TENNESSEE VALLEY AUTHORITY
River System Operations & Environment
River Operations

Hydrothermal Modeling of Browns Ferry Nuclear Plant With Units 1, 2, and 3 at Extended Power Uprate

WR2005-1-67-135

Prepared by
Paul N. Hopping
and
Walter L. Harper

Figure 11. Computed and Measured River Temperature Upstream of BFN for 1993

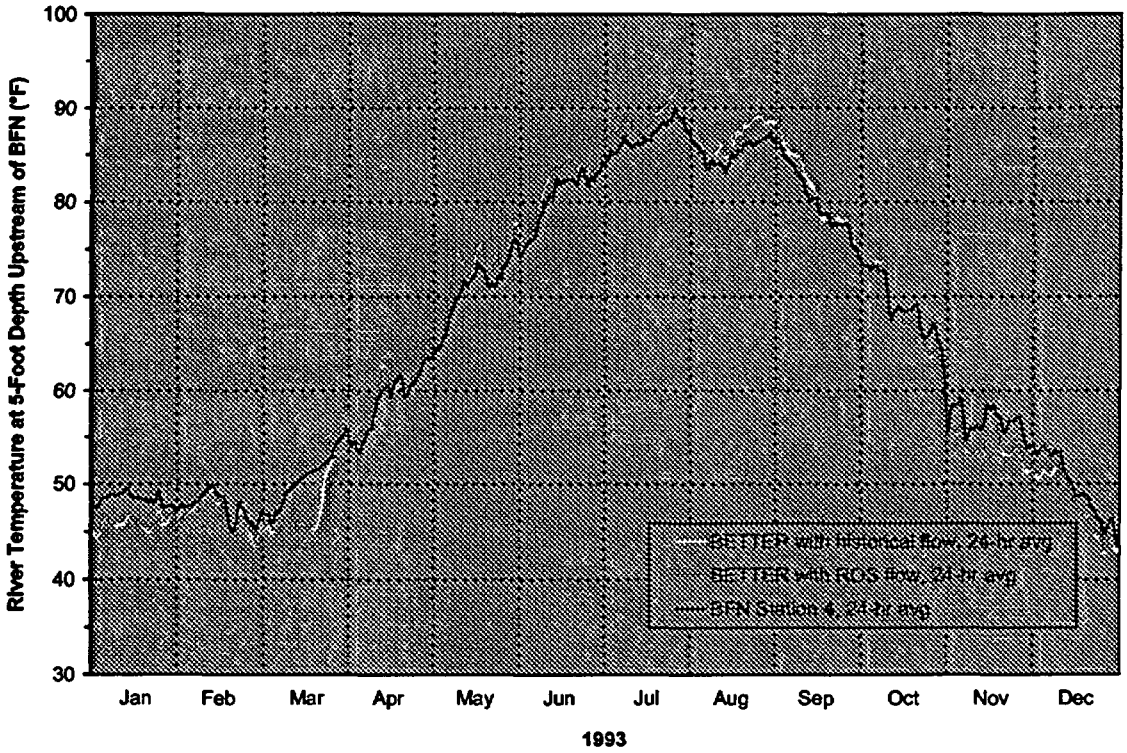
II.3.2 The response to Question 11, regarding Figure 11 and the effects of ROS releases on upstream river temperatures at the hourly scale, should be included in the report.

Figure 23. Computed vs. Measured Temperatures for Two-Unit Operation for Summer 2002

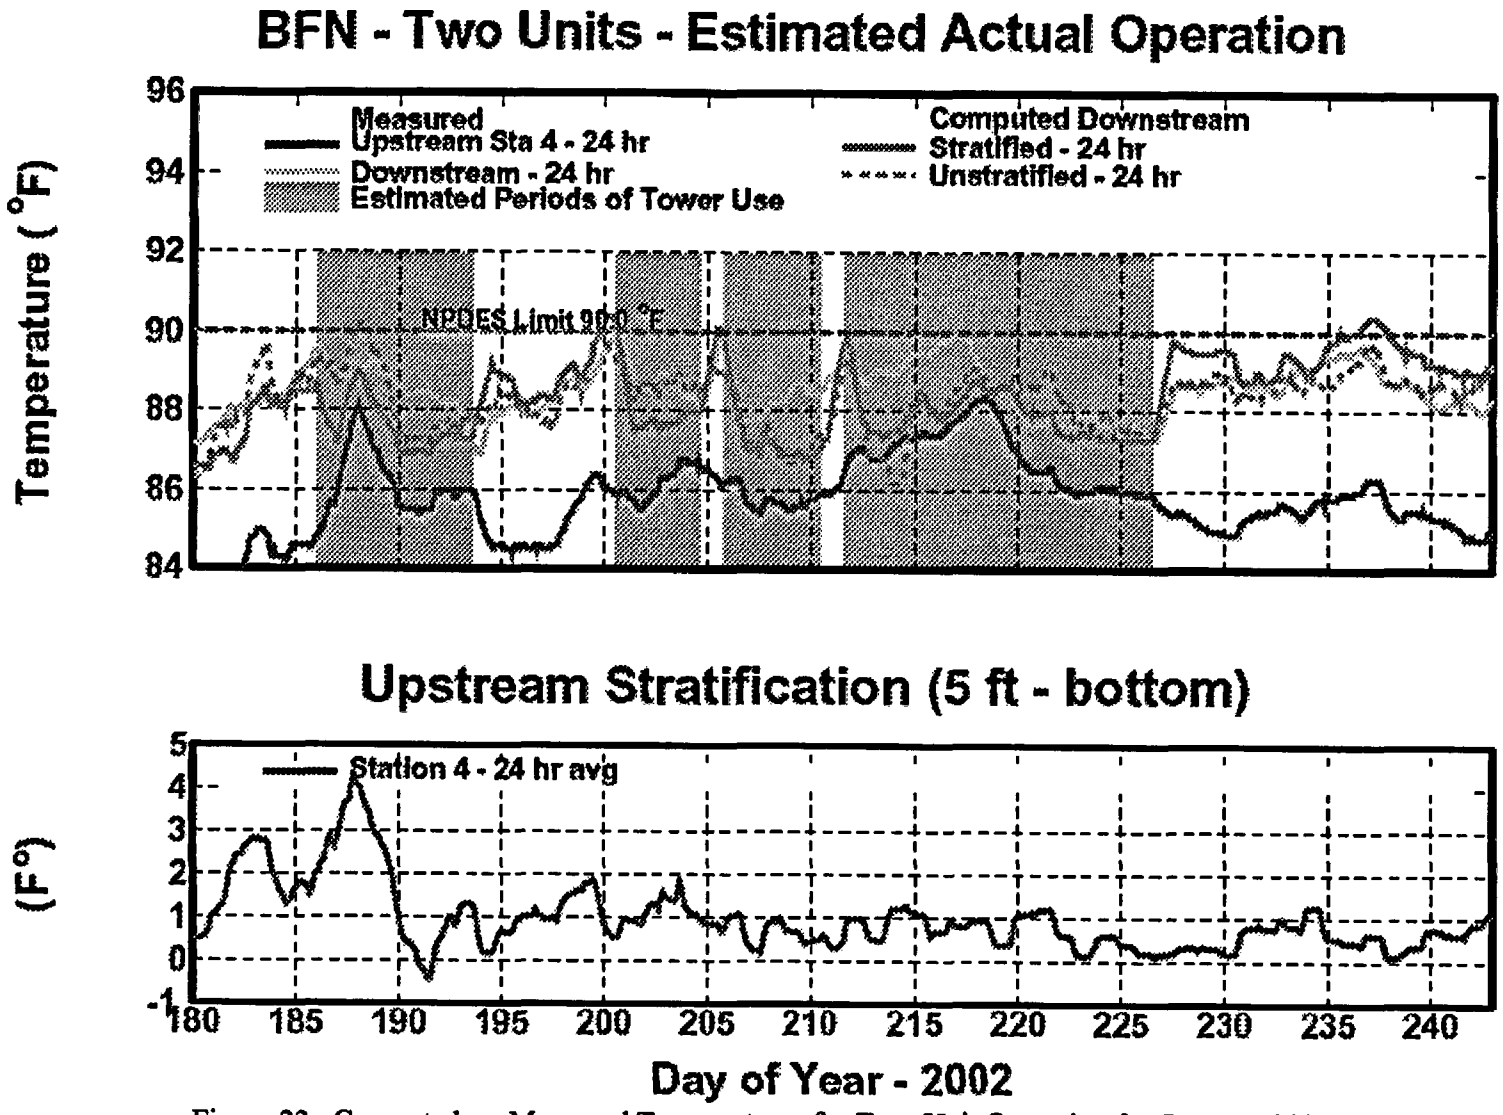
II.1.3 The rather poor agreement between the measured and computed downstream temperatures from days 206 to 218 in 2002, Figure 23, should be commented on in the text. Something else must have been going on.

Figure 25. Baseline (Case 0) Results for BFN Simulations

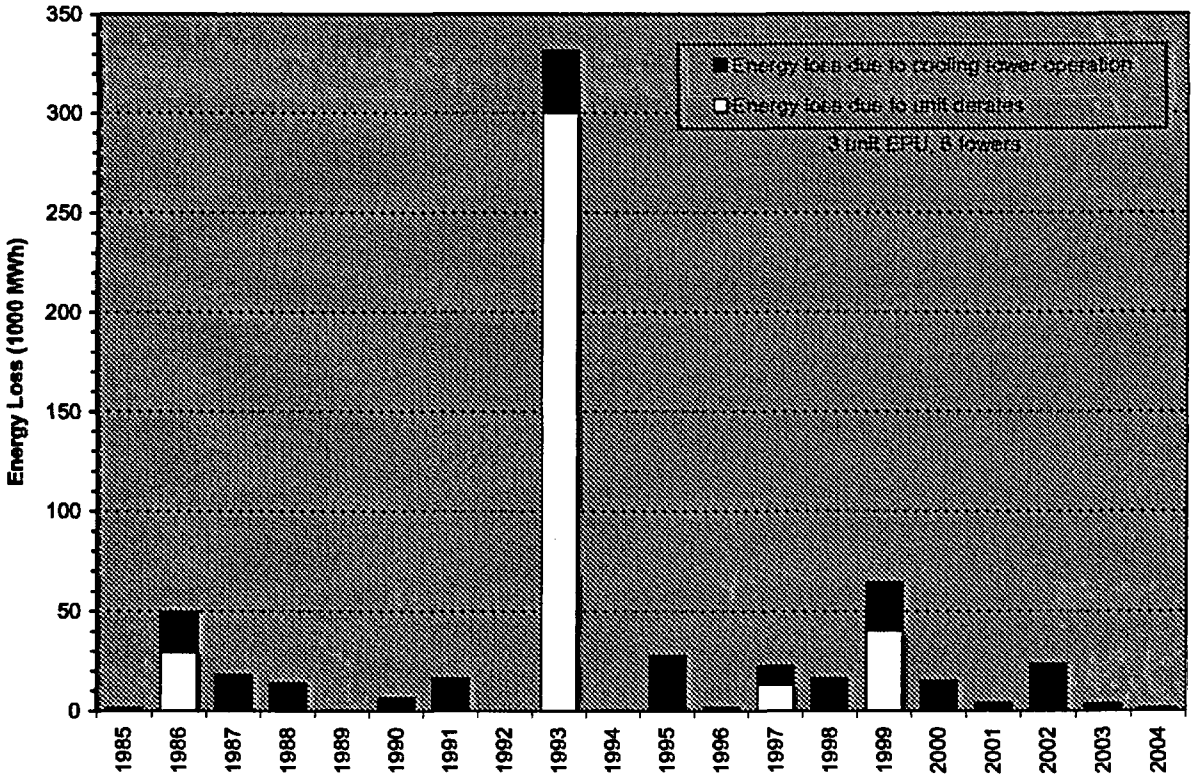
II.7.1 The Case 0 results as depicted in Figure 25 are not consistent with Table 9 from which they were drawn. However these same results as depicted in Figures 31, 32, and 33 appear to be correct.

Figure 26. BFN Operation for 1993

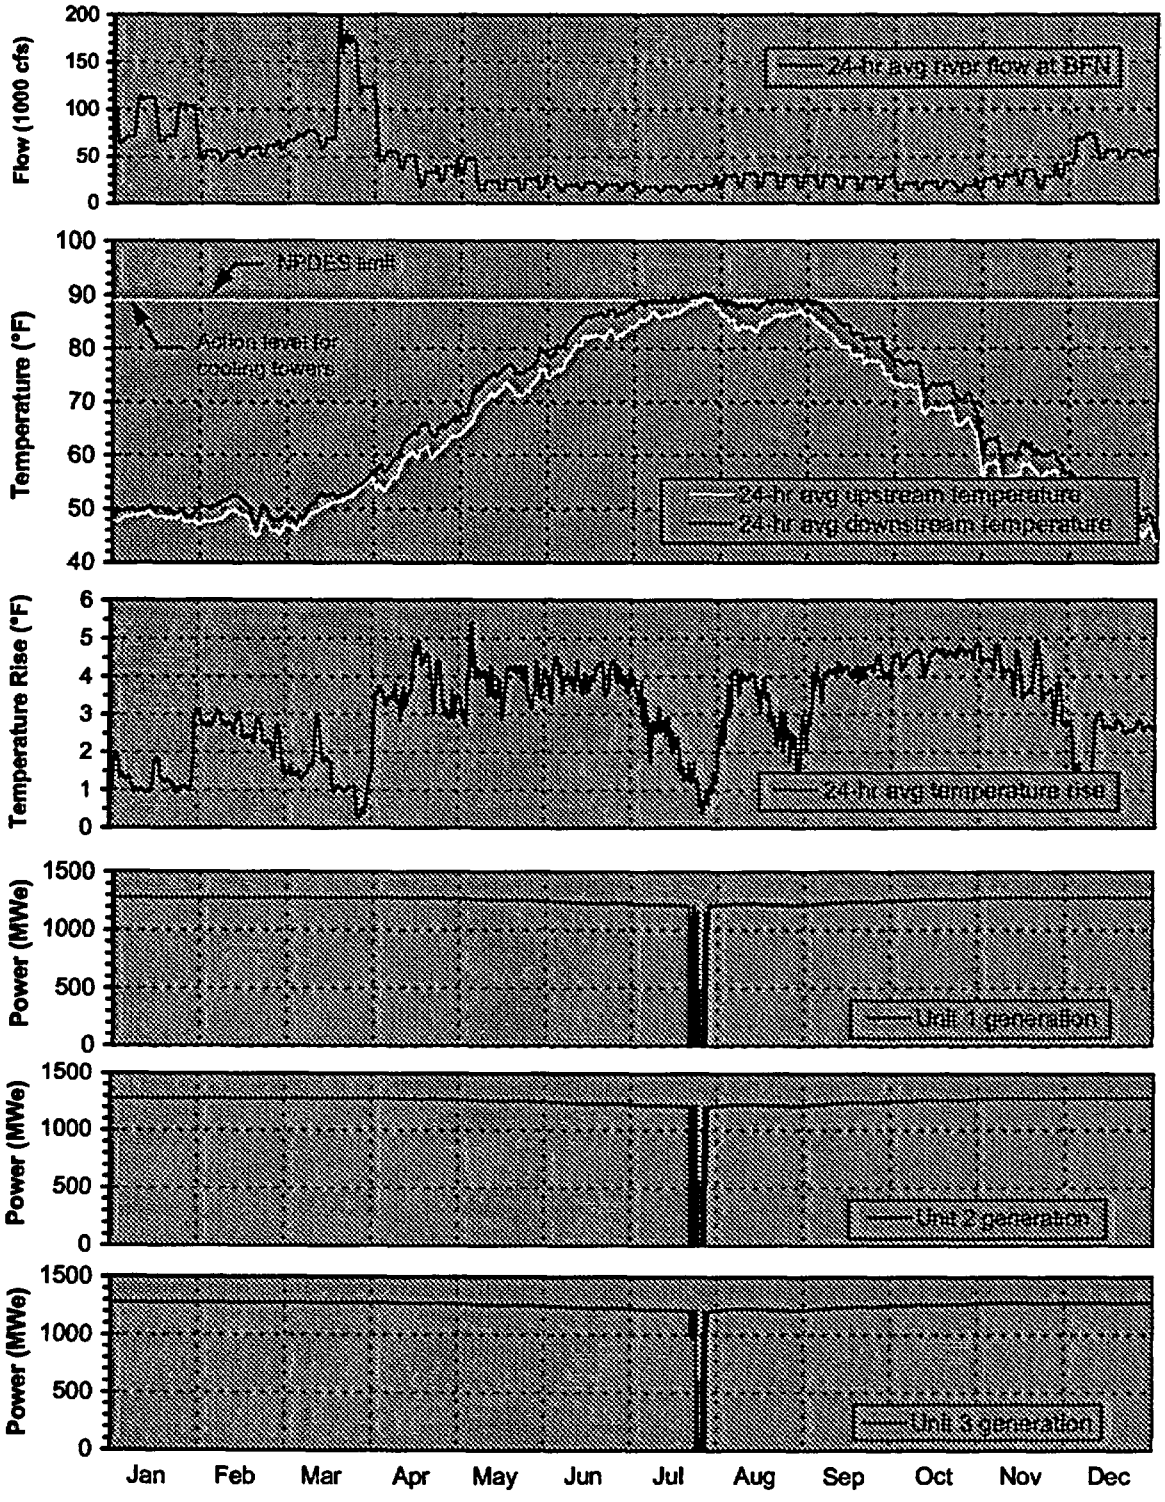
II.7.2 In Figures 26 and 27, one can infer when towers were in operation by the changes in the temperature rise. Nonetheless, if would be interesting to show tower operation directly, as the text refers to the timing of tower operation as well as unit derates. This would add one panel to the Figures, but it would make the Figures even more complete and informative.

Figure 27. BFN Operation for Late July 1993

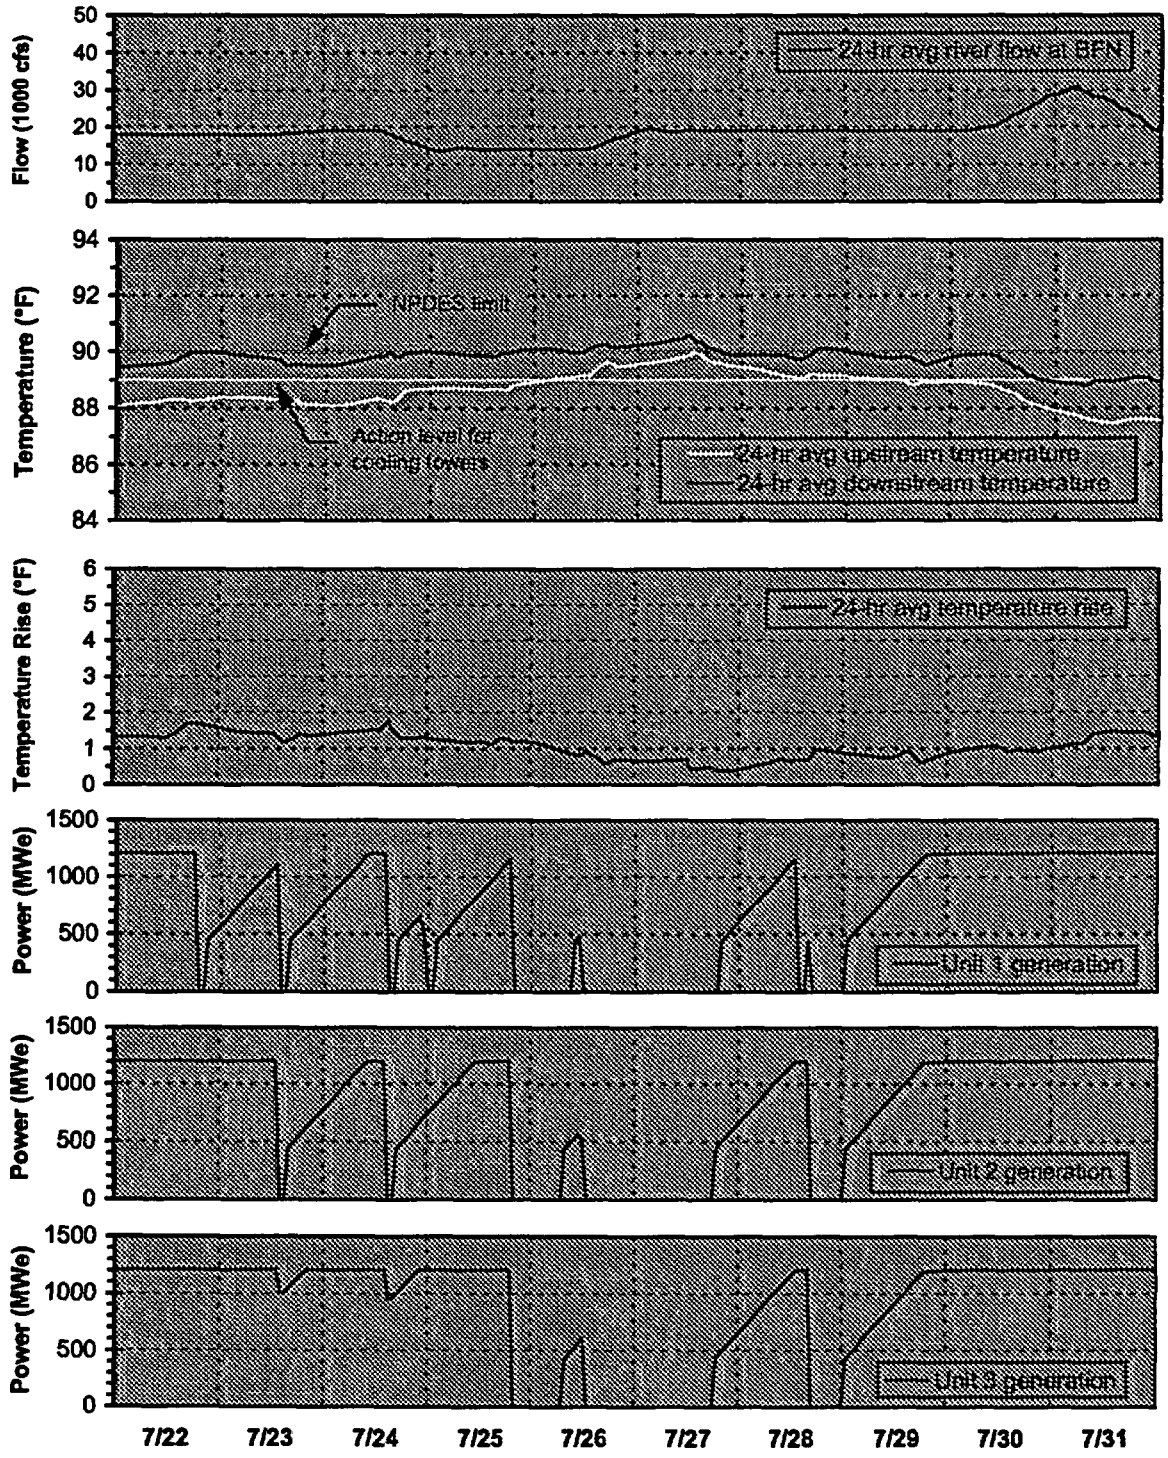
II.1.5 Figure 27 seems to suggest that the model predicted an apparent NPDES permit violation on 26-27 July of 1993 – yet in the model the units were shut down. There is

Figure 29. Effect of Condenser Cleanliness Factor on Condenser Temperature Rise

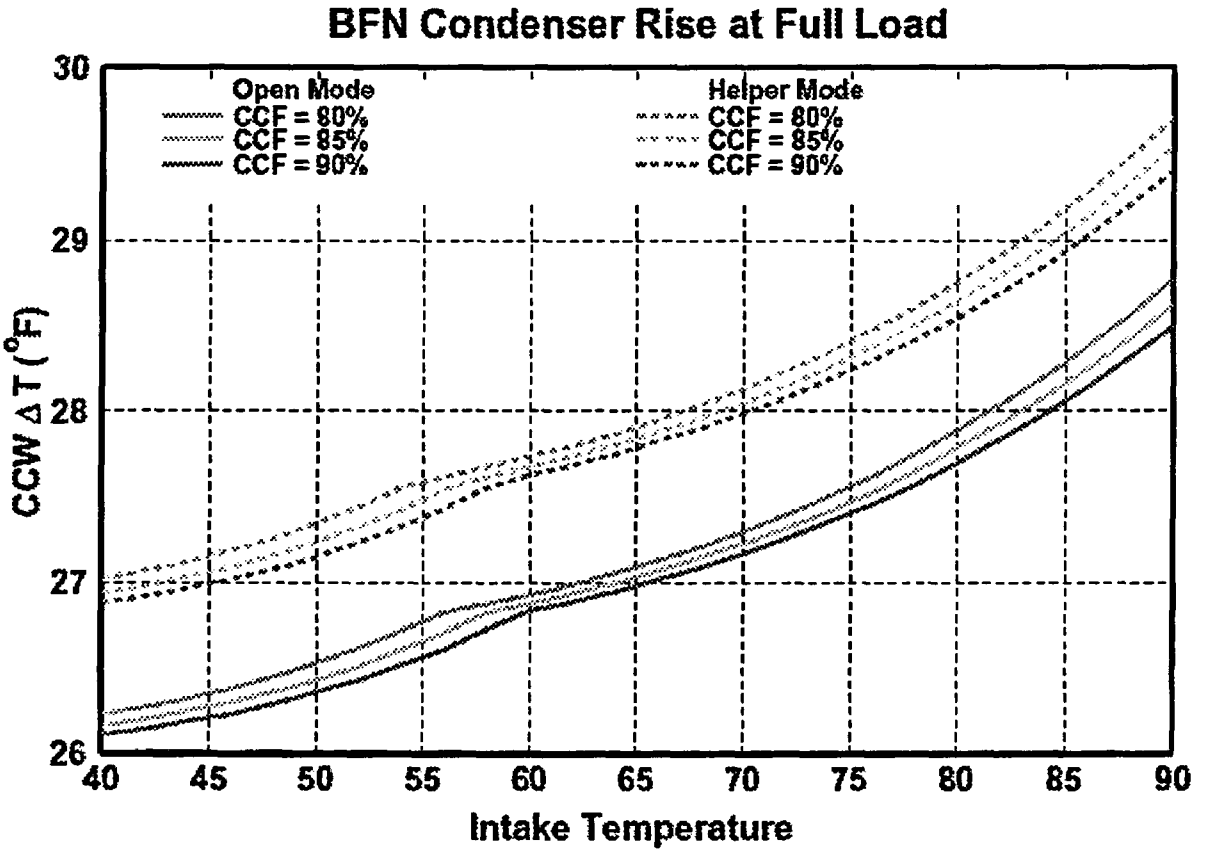
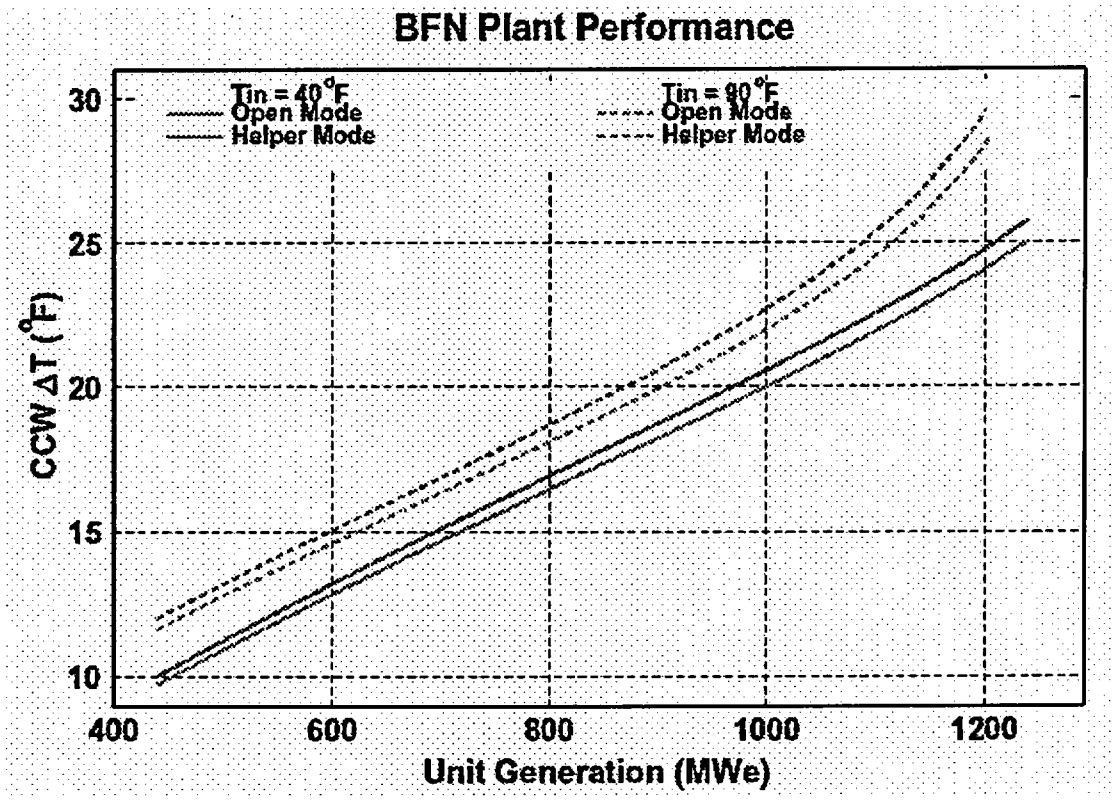
II.3.1 Figure 29 has some strange kinks in the condenser curves that do not appear to be reflected in Figure 16. These are not the same presentation, but it would be helpful if the authors could explain the anomalies in the curves, if in fact they are anomalies.
